## World Forum for Harmonization of Vehicle Regulations

# Proposal for Supplement 1 to the 02 series of amendments to Regulation No. 110 (CNG and LNG vehicles)

#### Submitted by the Working Party on General Safety Provisions\*

Figure 1 **Dimensions of the receptacle**

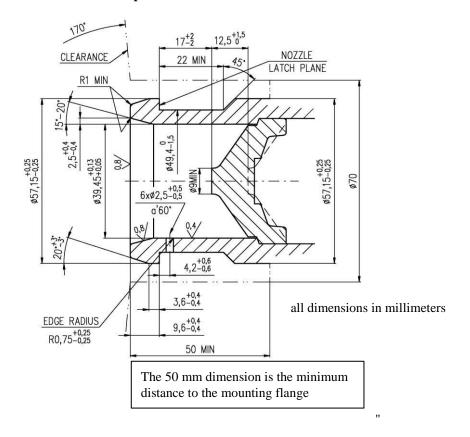
*Insert new paragraphs 4. and 4.1.*, to read:

- "4. LNG filling receptacle dimensions
- 4.1. Figure 1 shows the dimensions of the LNG filling receptacle.
